ADDENDUM NUMBER TWO (2)

Project: "The Commons" Buildings
Hinds Community College – Rankin Campus
Pearl, MS
HCC Bid #3307
PN: 24053

FROM: Dean Architecture, P.A.
661 Sunnybrook Road, Suite 140
Ridgeland, MS 39157
(601) 939-7717

10 / A509 CLOSET ROD/SHELF

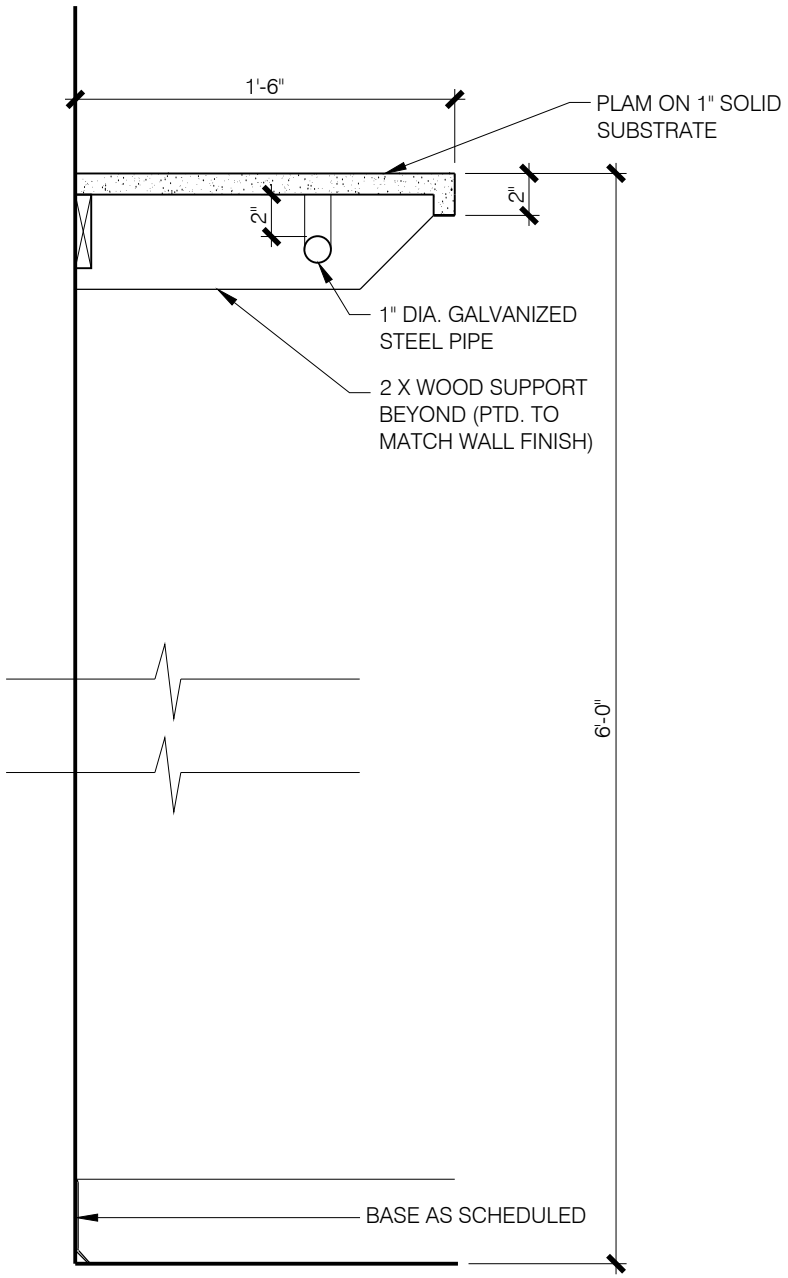
ITEM #8: SHEET A509 – MILLWORK DETAILS.
Add detail 10/A509 Shown on the attached supplemental drawing SD-1/A509. This denotes a hanging rod and shelf required at all Residence Hall closets. There are two closets in each residence room.

1 A201 **NORTH ELEVATION**

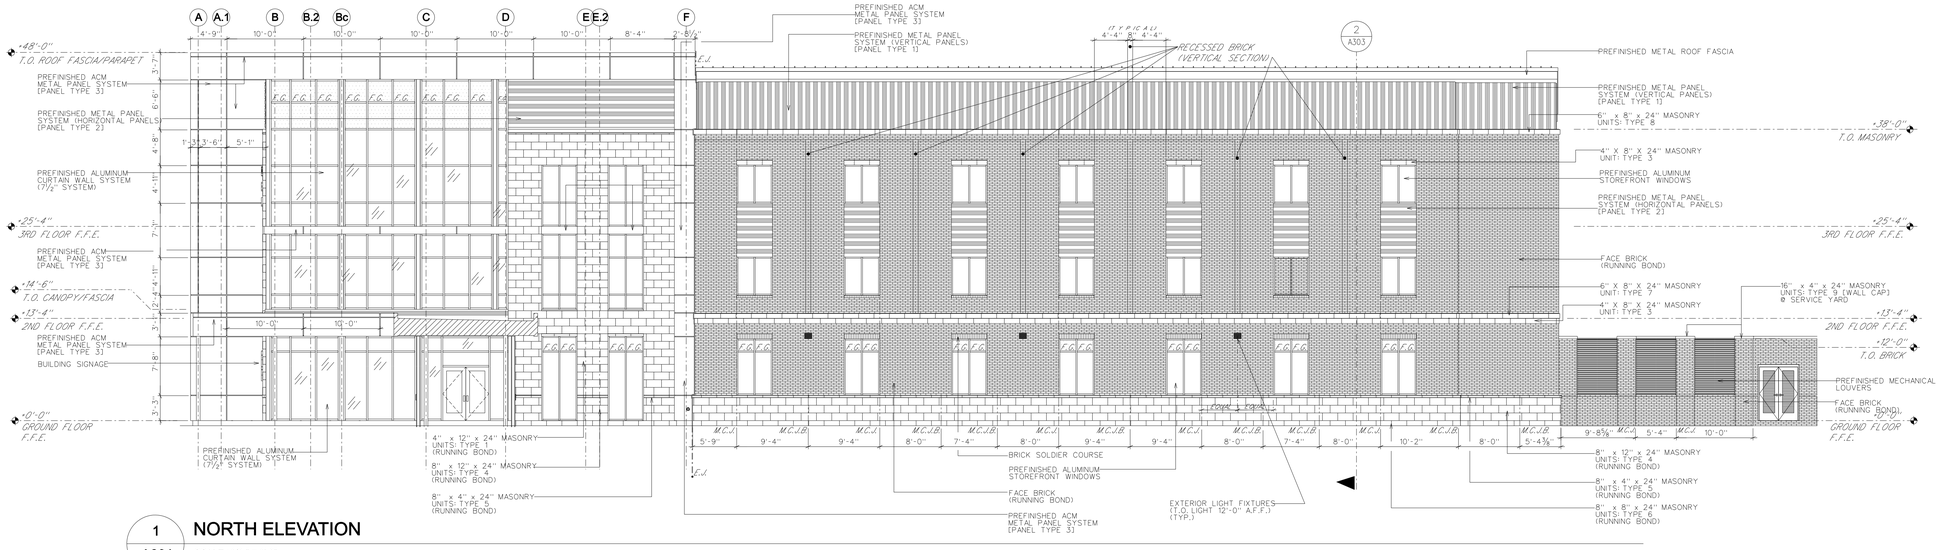
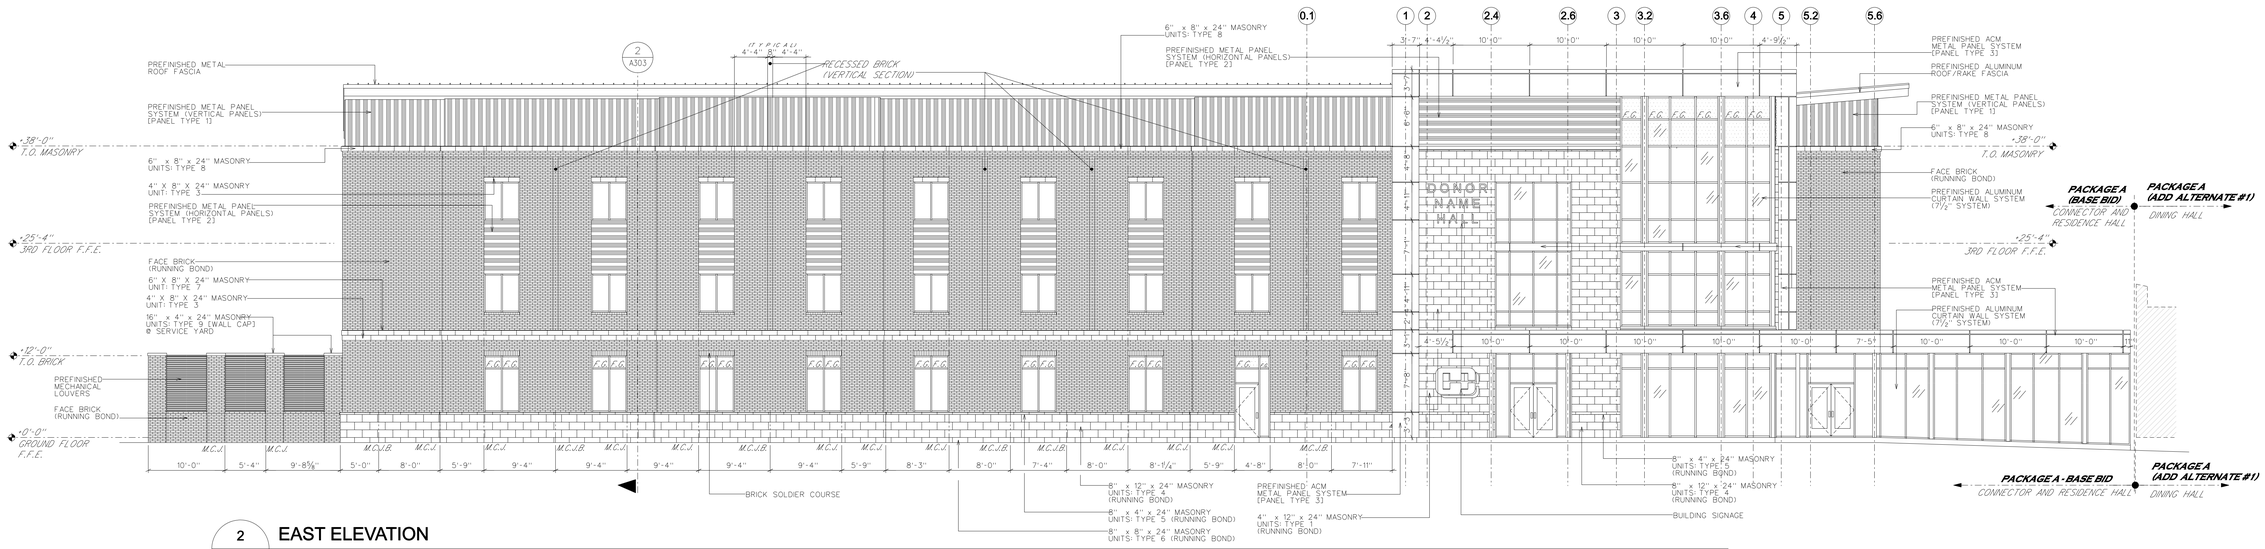
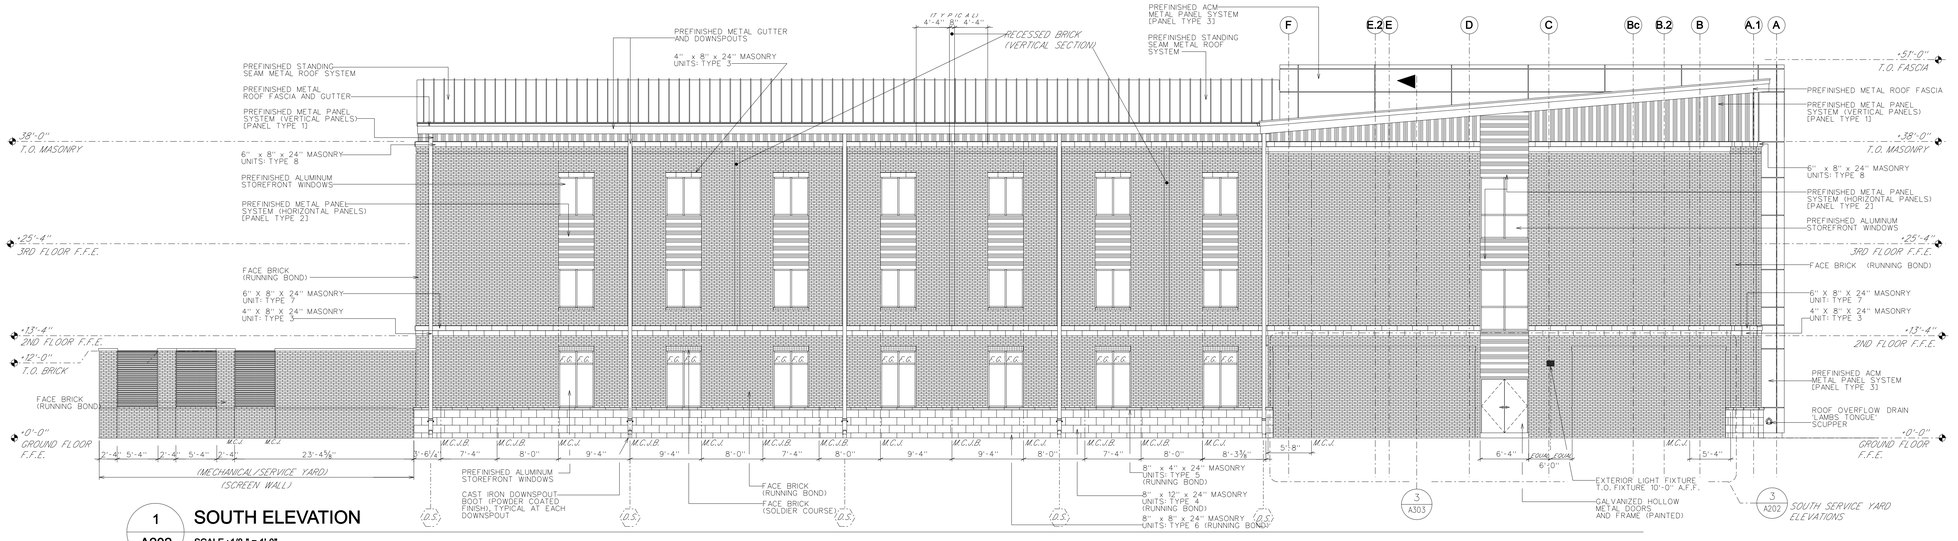
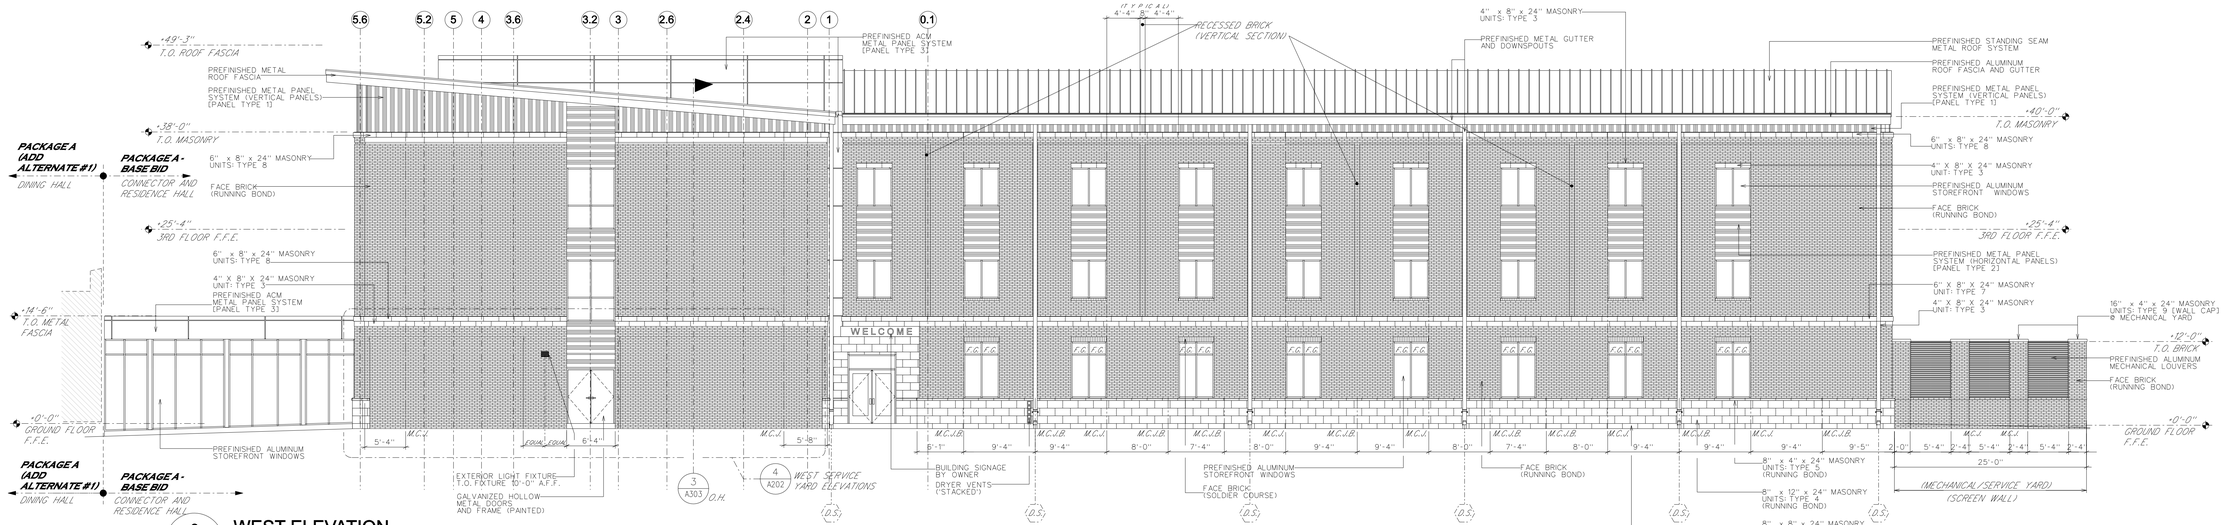
ITEM #5: SHEETS A201 AND A202 – RESIDENCE HALL EXTERIOR ELEVATIONS.
Remove existing sheets and replace with revised sheets.
Changed wall section keys to 1/A308 and 2/A308 in lieu of sheet A309.

Sheet Number:
A503
RESIDENCE HALL ENLARGED THIRD FLOOR PLAN & RCP

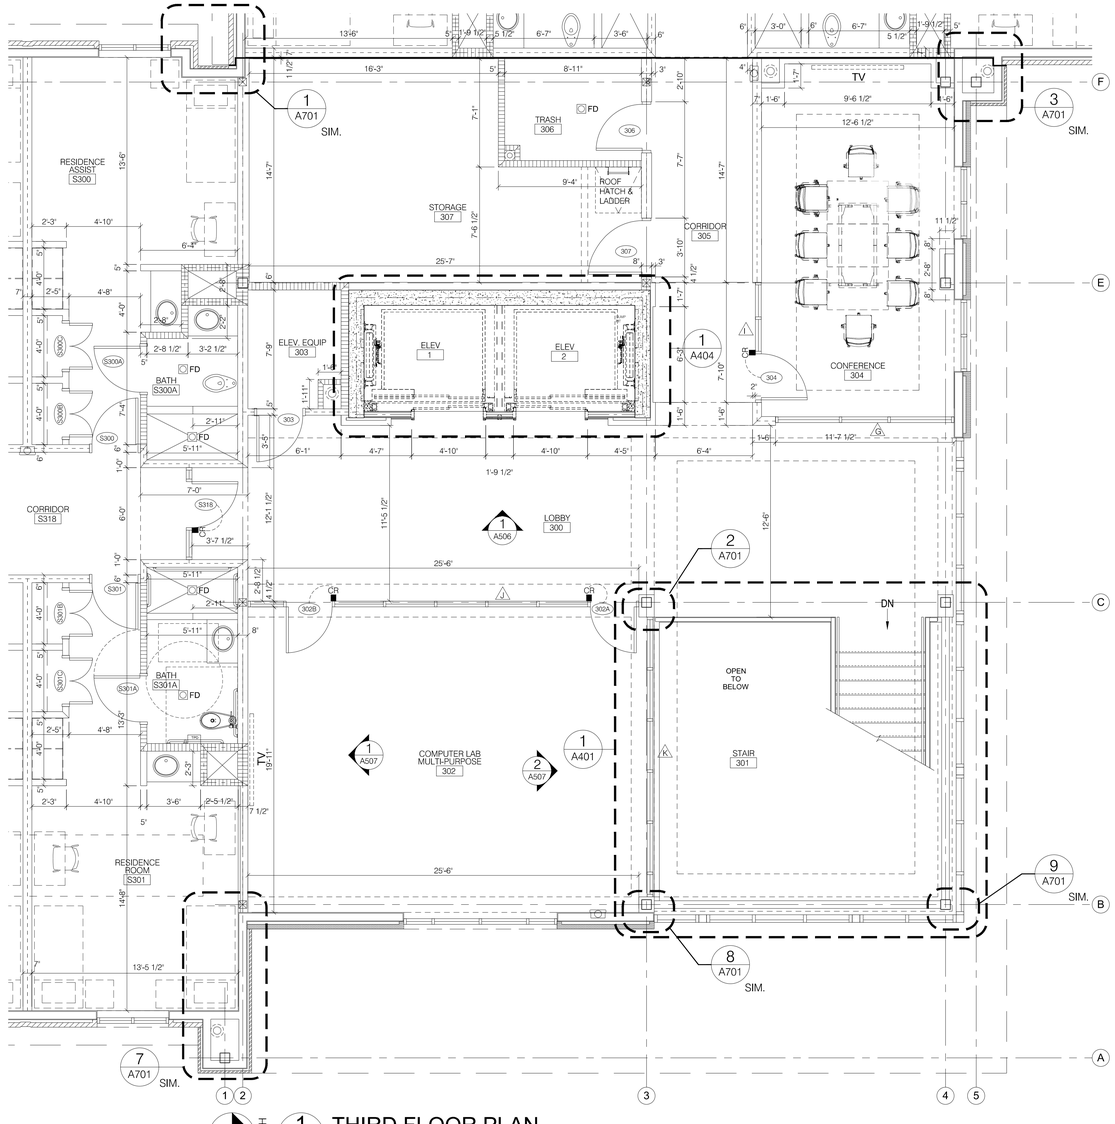
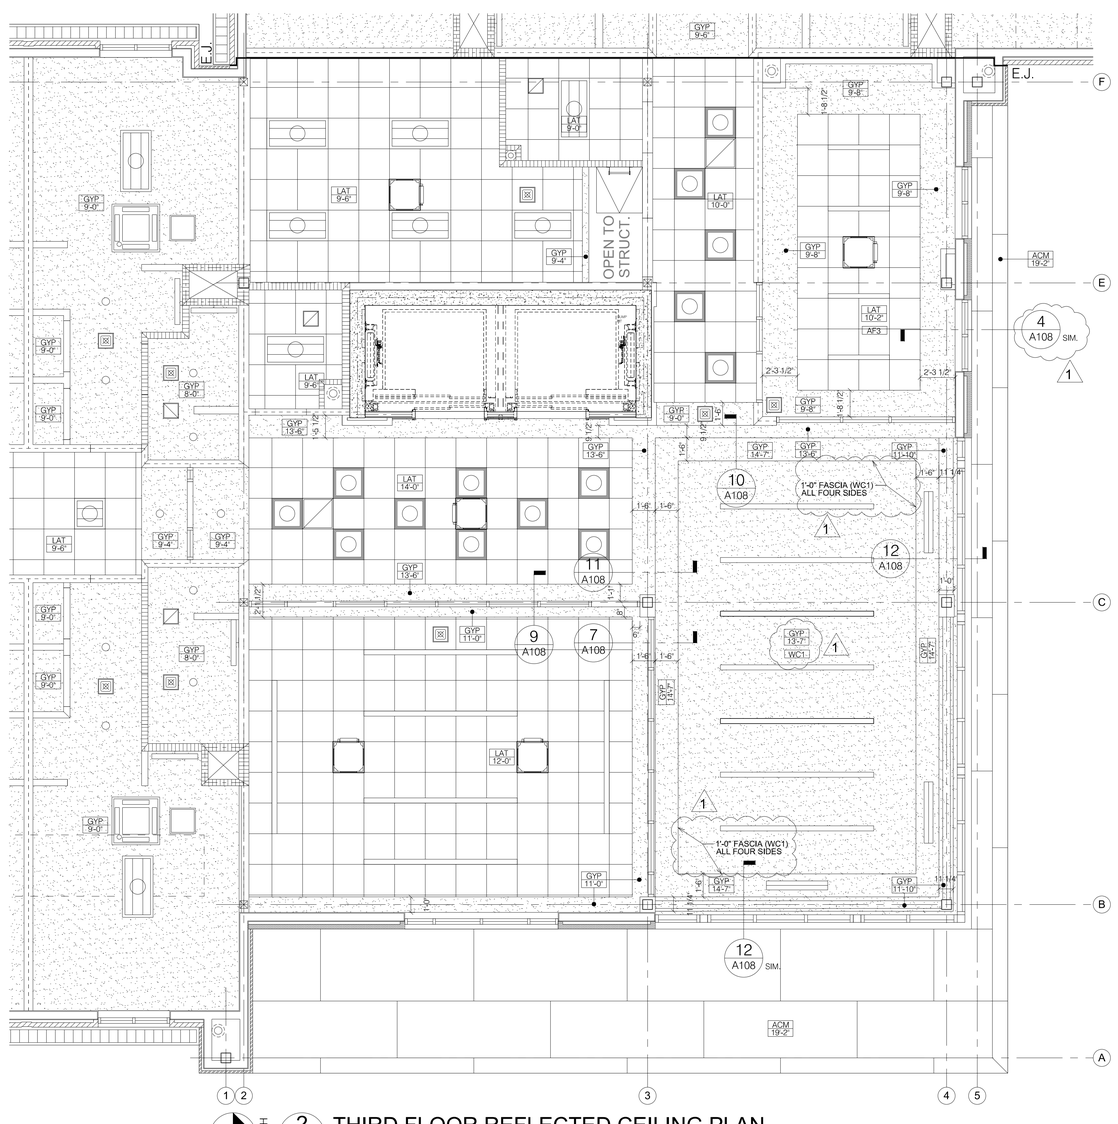
ITEM #7: SHEET A503 – ENLARGED THIRD FLOOR R. C. P.
Remove existing sheet and replace it with revised sheet. Clarified WC1 on GYP. BD. Ceiling above lobby stair.

1 A121 ENLARGED SITE PLAN
SCALE: 1/8"=1'-0"

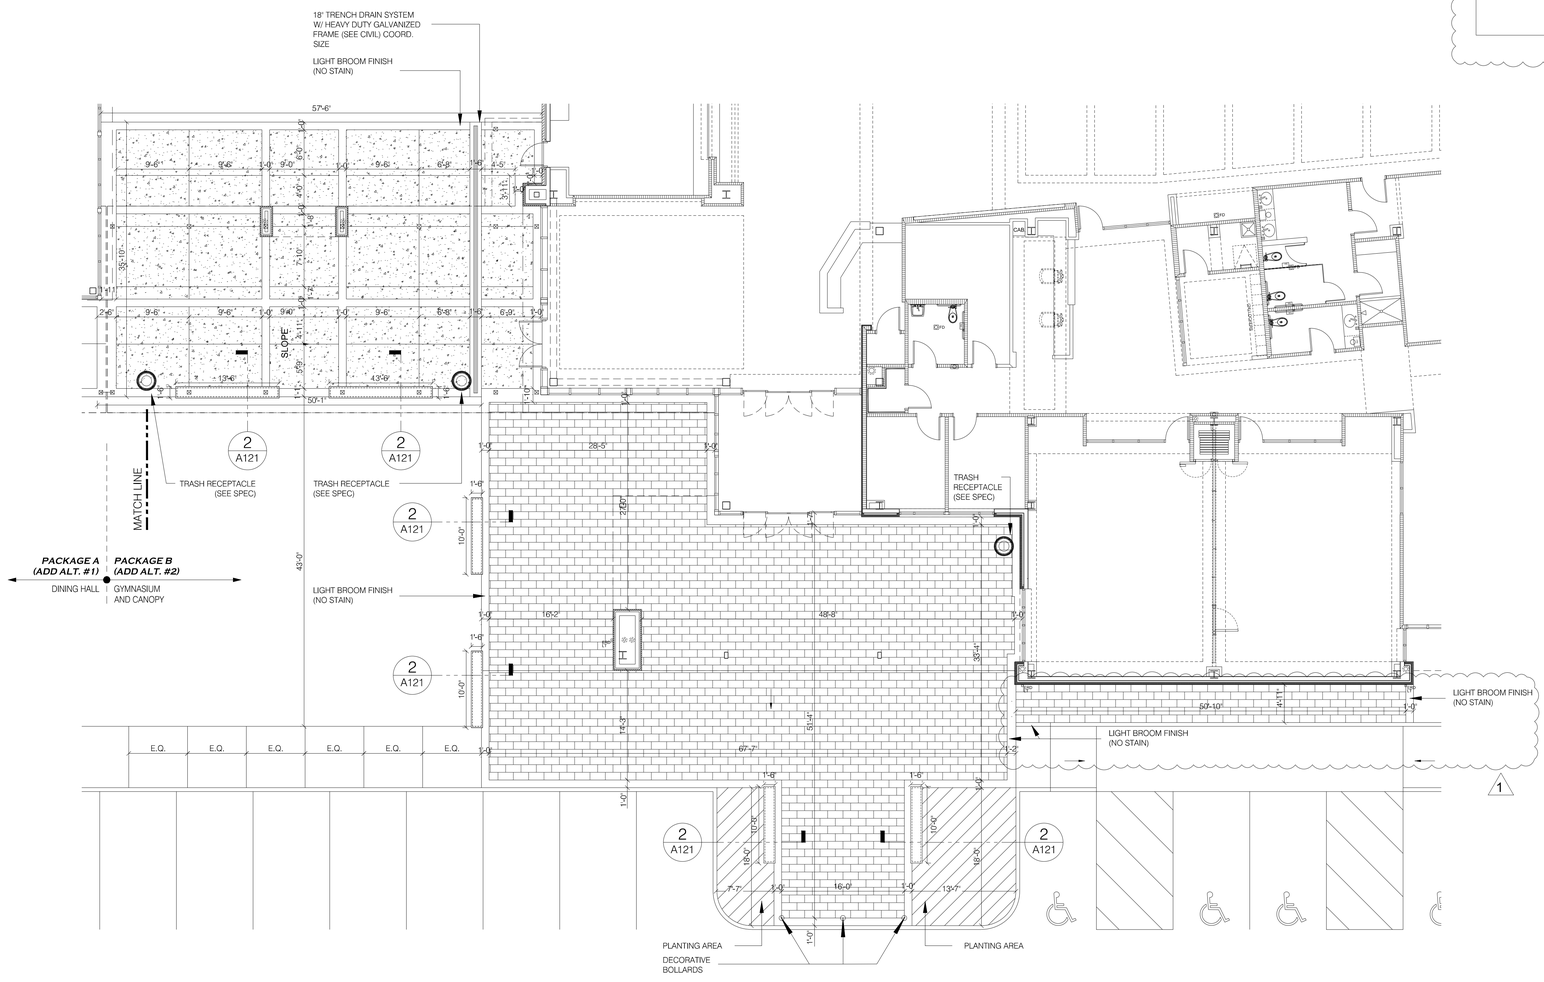
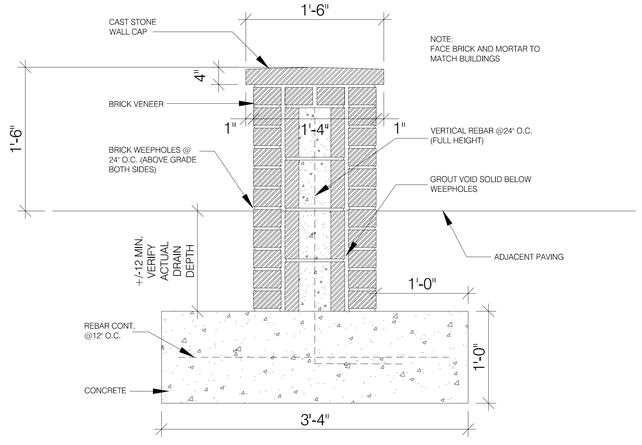
ITEM #4: SHEET A122 - ENLARGED SITE PLAN.
Remove existing sheet and replace it with the revised sheet. Revised entry sidewalks and scope of work at Irl Dean Rhodes Building entry. Added paver information.

4 / E021 ONE LINE DIAGRAM - GYM

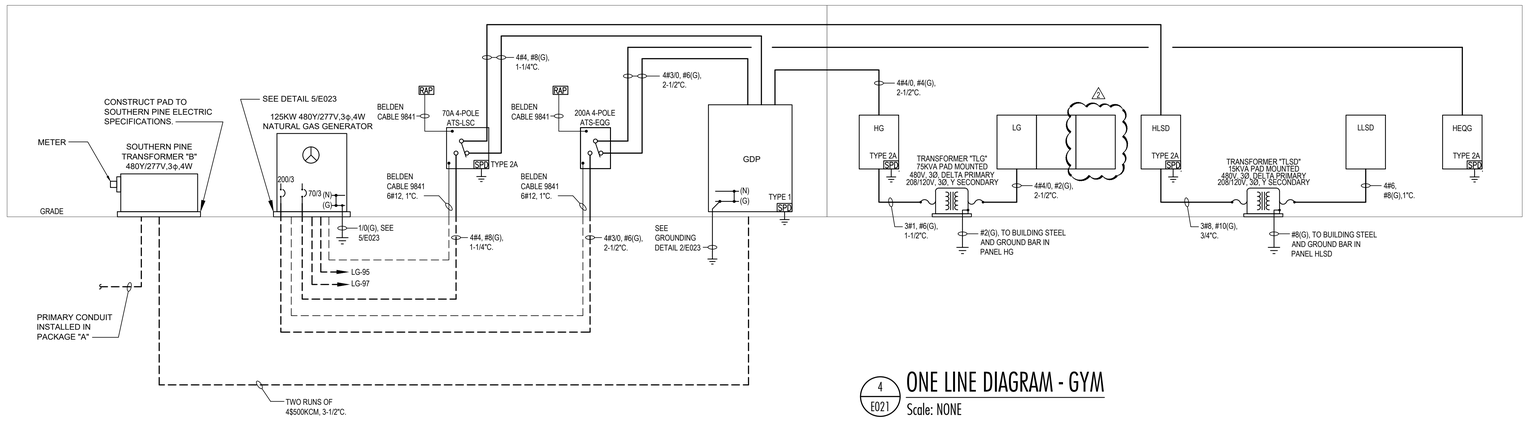
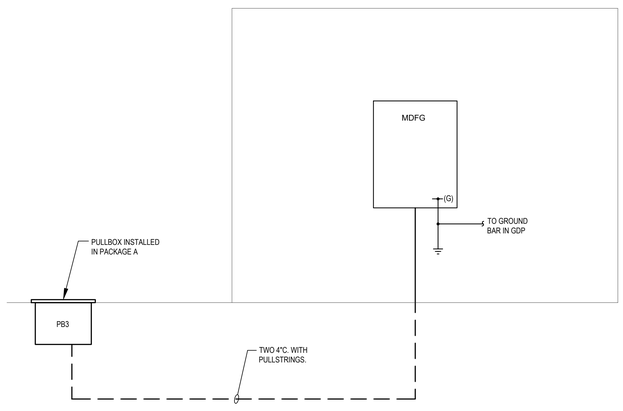
Item #13 – Sheet E021 – Replaced sheet in its entirety. Modified one line diagram.
Item #14 – Sheet E024 – Replaced sheet in its entirety. Modified panel schedules.
Item #15 - Sheet E220 – Replaced sheet in its entirety. Modified power plan.
Item #16 -Sheet E320 – Replaced sheet in its entirety. Modified mechanical plan.
Item #17 – Sheet E420 – Replaced sheet in its entirety. Modified auxiliary plan.
